W31: IH-10 Boerne Stage to Old Fredericksburg Sanitary Sewer

Job No.: 09-2502

ADDENDUM 2

October 4, 2016

SHEET NUMBER **C - 12**
 SHEET 65 OF 135

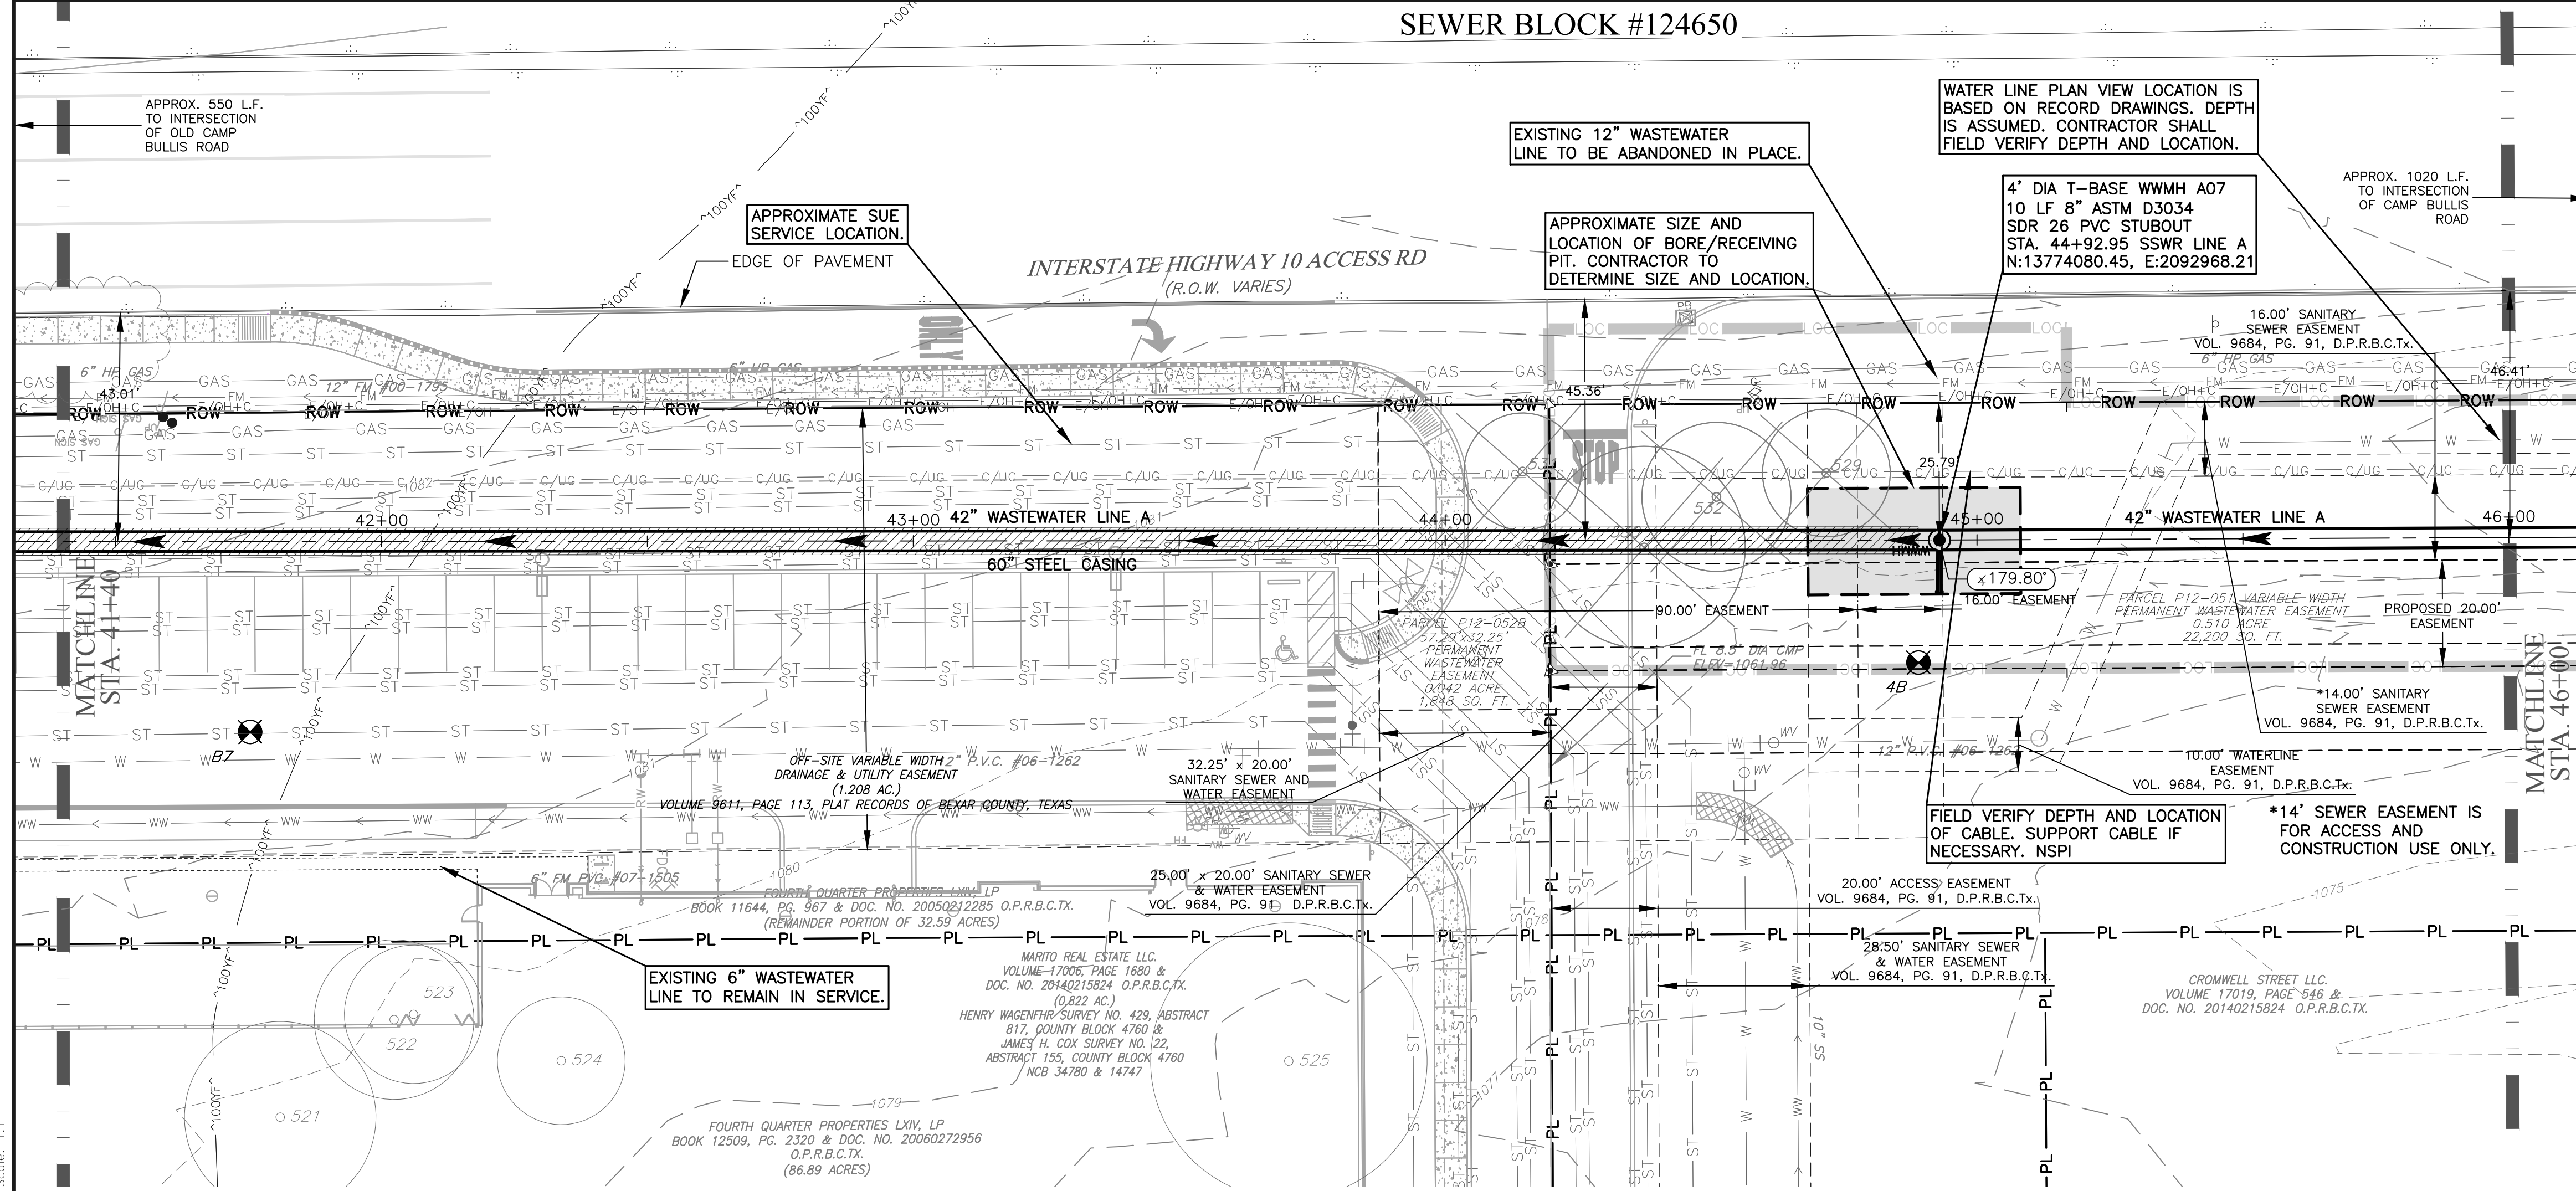
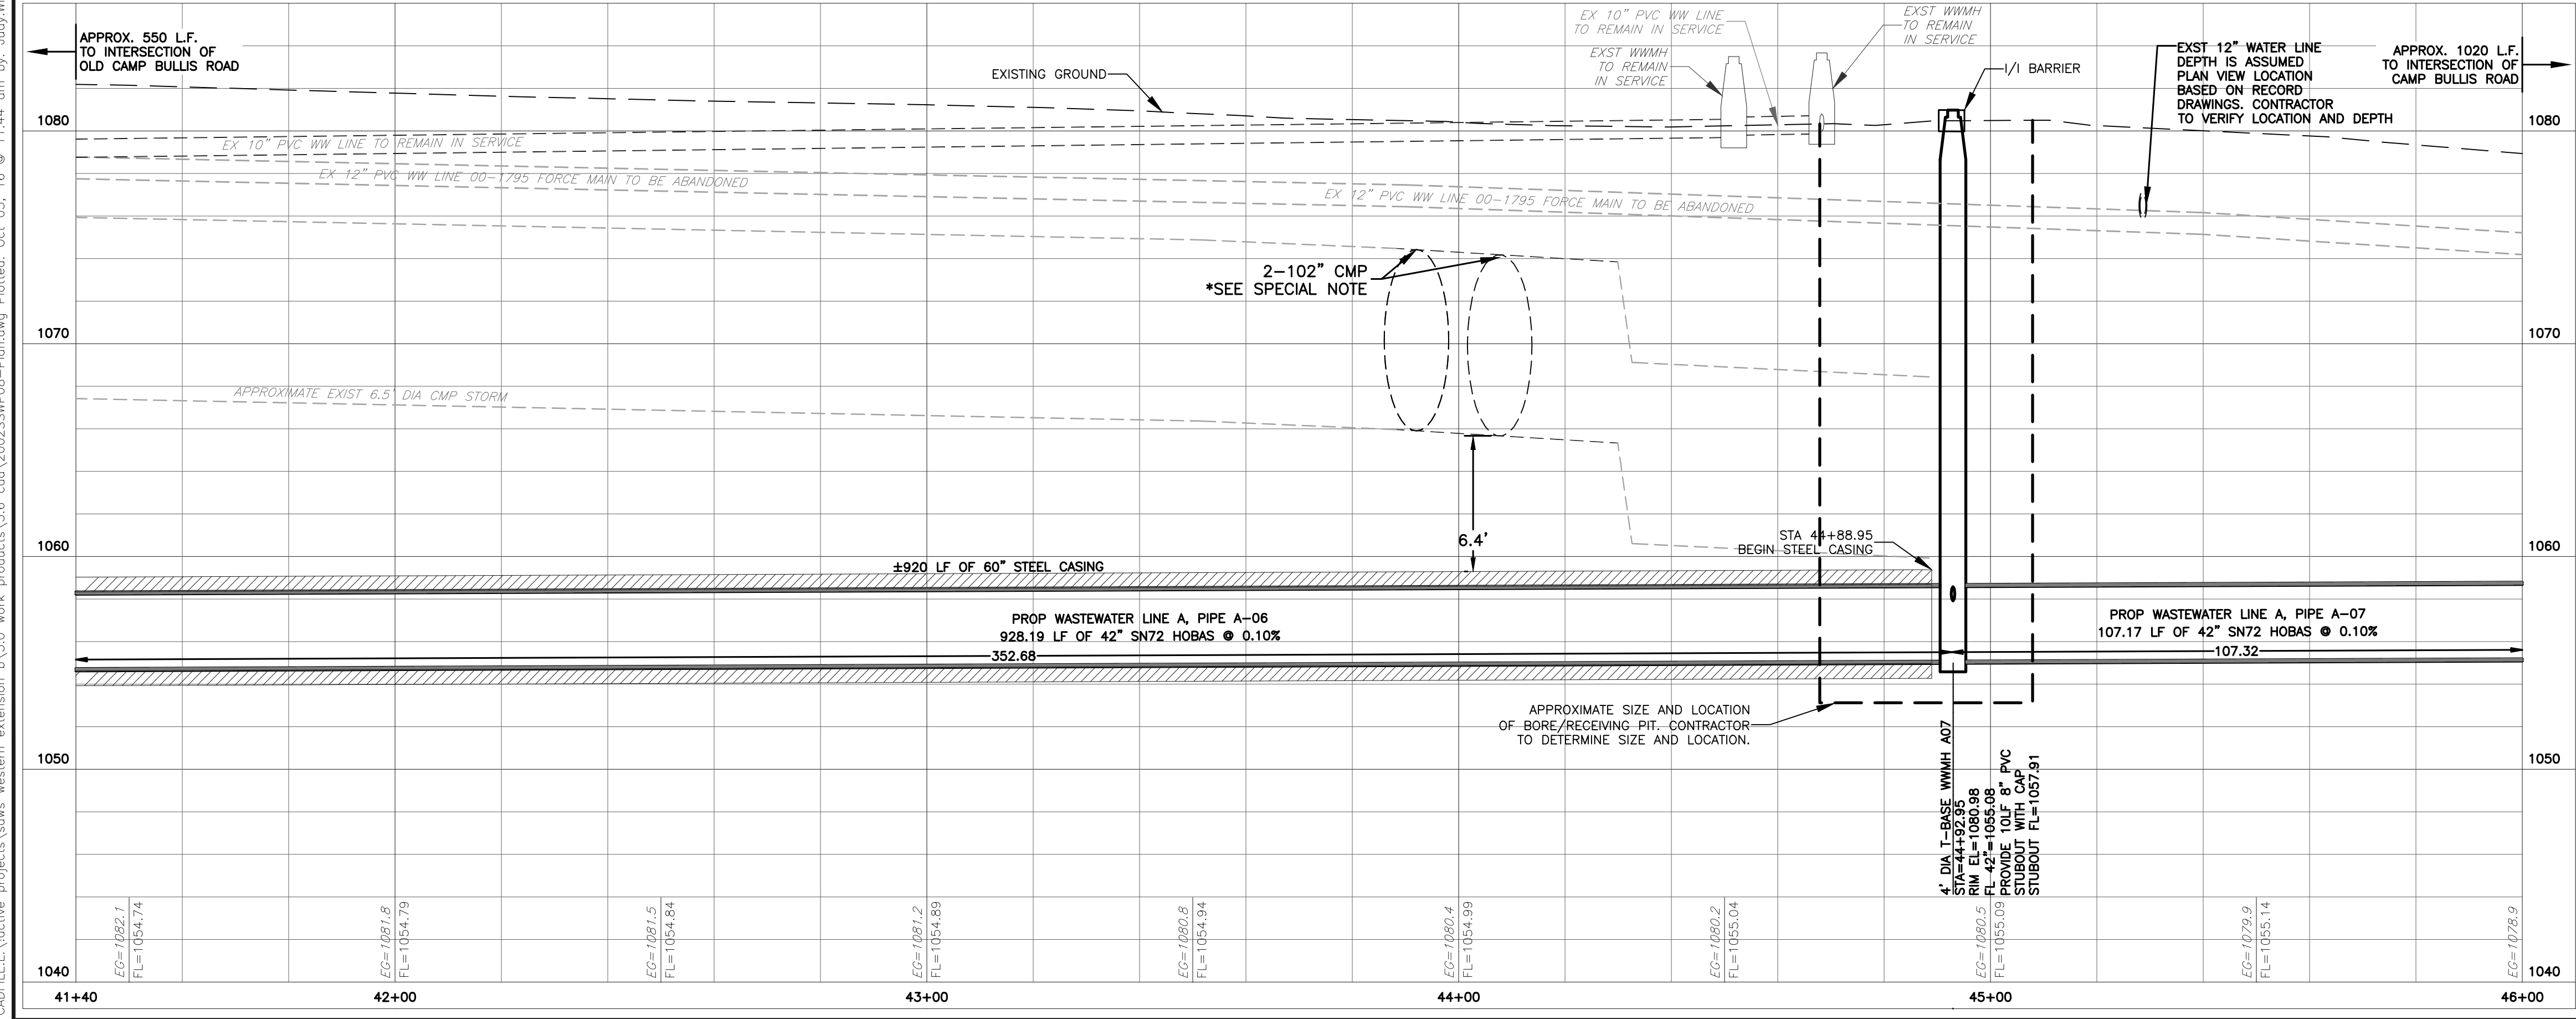
3. The following note was added to Sheets C-9, C-10, C-12, C-13, C-14, C-15, C-45, and C-46:

"The Contractor shall provide the property owner a written notice of initial entry 10 days prior to start construction within their property."

- SPECIAL NOTES:**
- THE ELEVATIONS OF THE TWO (2) 102-INCH CMP HAVE BEEN CONFIRMED VIA SUE SERVICES. THE DESIGN ENGINEER AND CMP SUPPLIER FOR THAT PROJECT HAVE INDICATED THAT A BEDDING ENVELOPE EXTENDING TO APPROXIMATELY 6 INCHES BELOW THE FLOWLINE IS ANTICIPATED BUT THIS COULD NOT BE CONFIRMED PRIOR TO CONSTRUCTION. CONTRACTOR SHALL BE RESPONSIBLE FOR PRESERVING THE BEDDING ENVELOPE BENEATH THE CMP CULVERTS (NSPI).
 - THE CONTRACTOR SHALL PROVIDE THE PROPERTY OWNER A WRITTEN NOTICE OF INITIAL ENTRY 10 DAYS PRIOR TO START CONSTRUCTION WITHIN THEIR PROPERTY.

SHEET NUMBER	C - 13
SHEET	66 OF 135

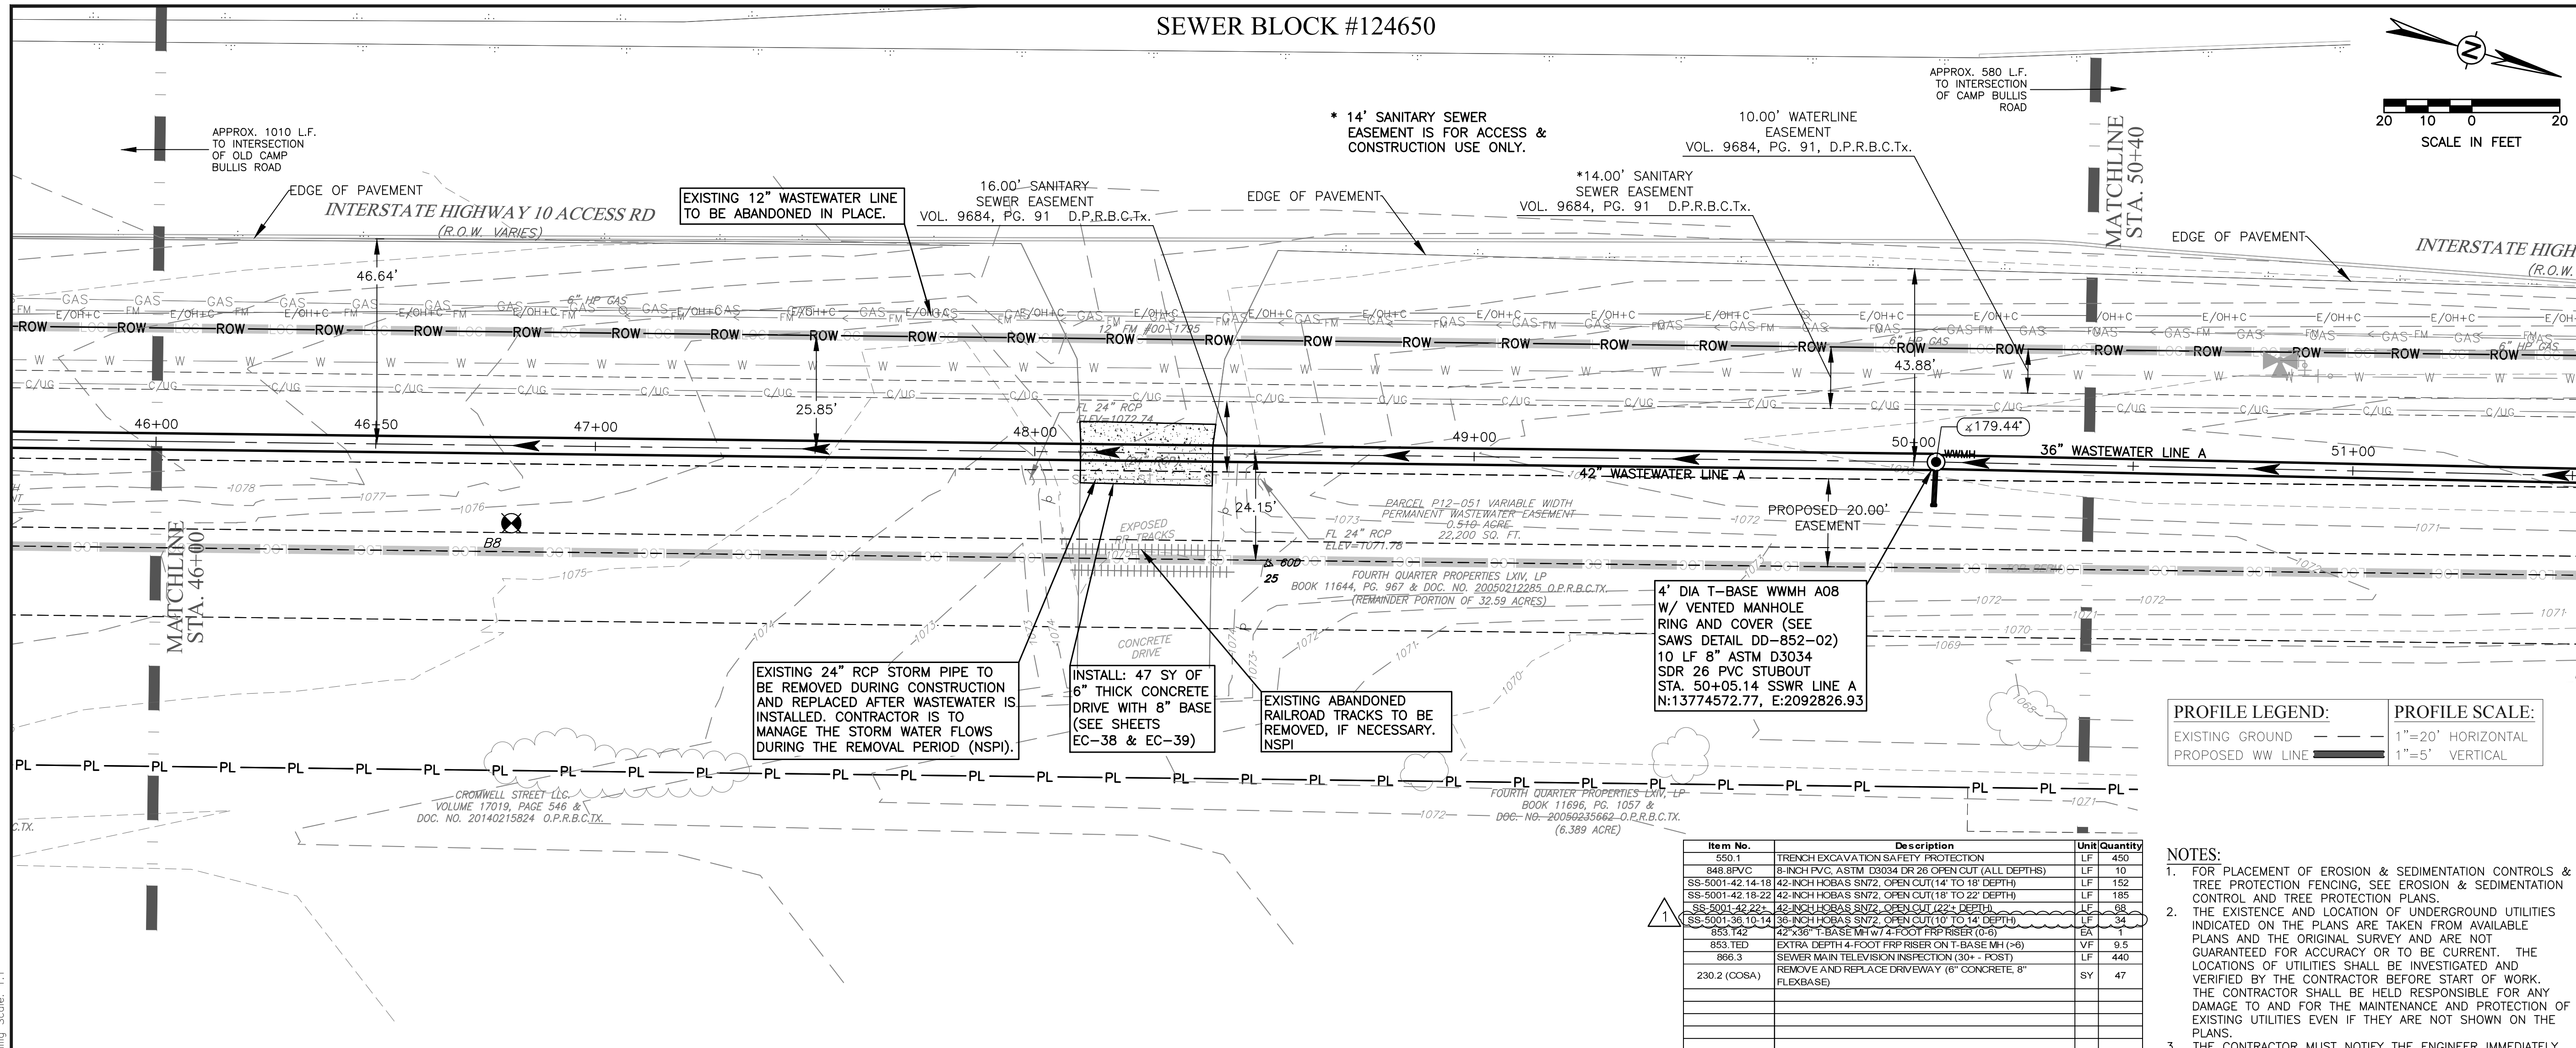
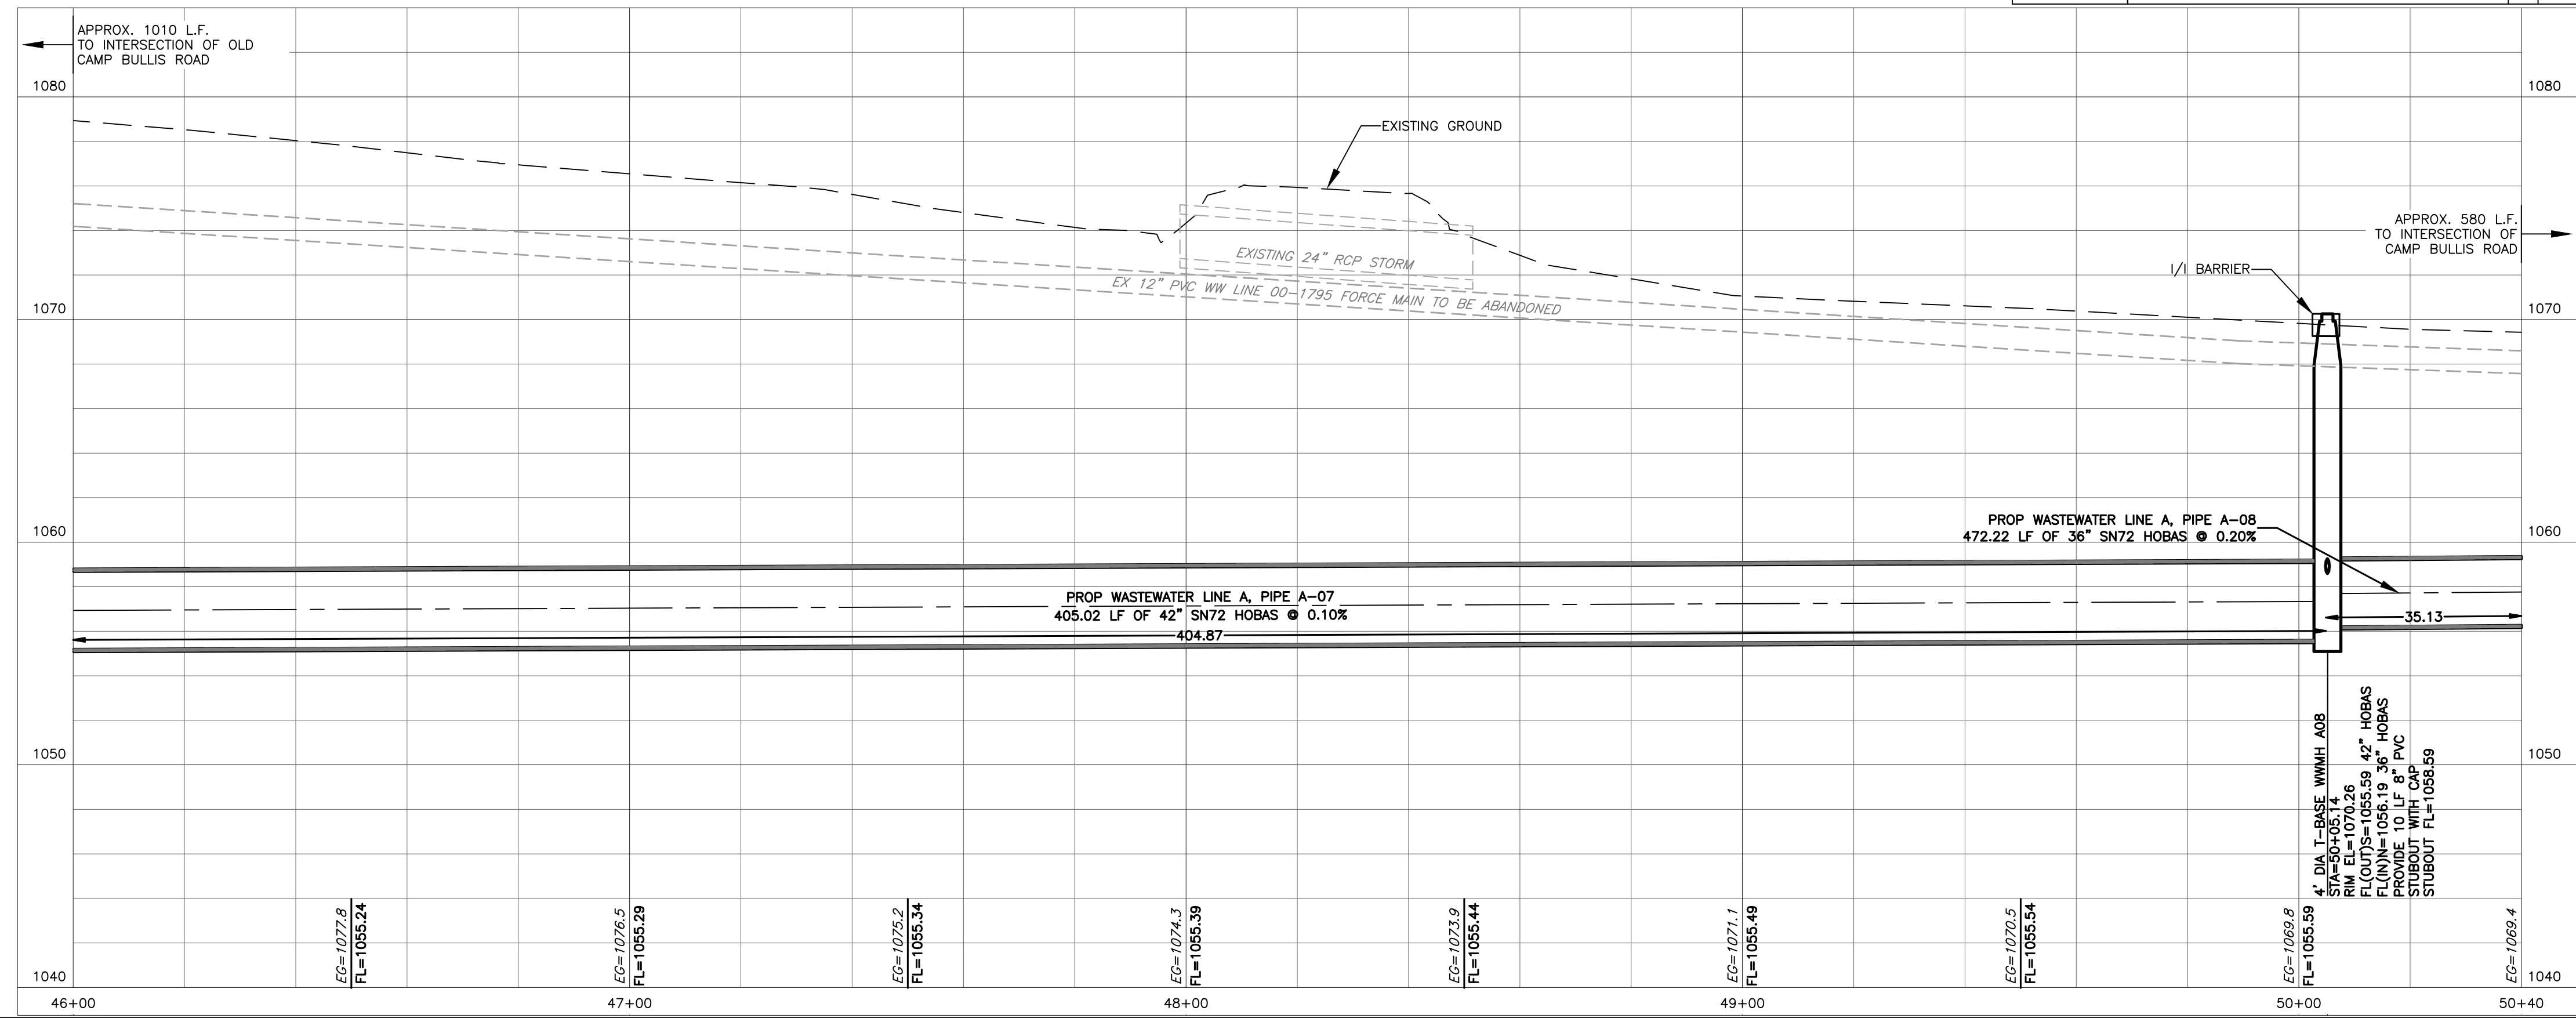
4. On Sheet C-13, in the quantities table, Item No. SS-5001-42.10-14 should be SS-5001-36.10-14 and the Description should read 36-inch Hobas SN72, OPEN CUT (10' TO 14' DEPTH).

SPECIAL NOTE:
 1. THE CONTRACTOR SHALL PROVIDE THE PROPERTY OWNER A WRITTEN NOTICE OF INITIAL ENTRY 10 DAYS PRIOR TO START CONSTRUCTION WITHIN THEIR PROPERTY.
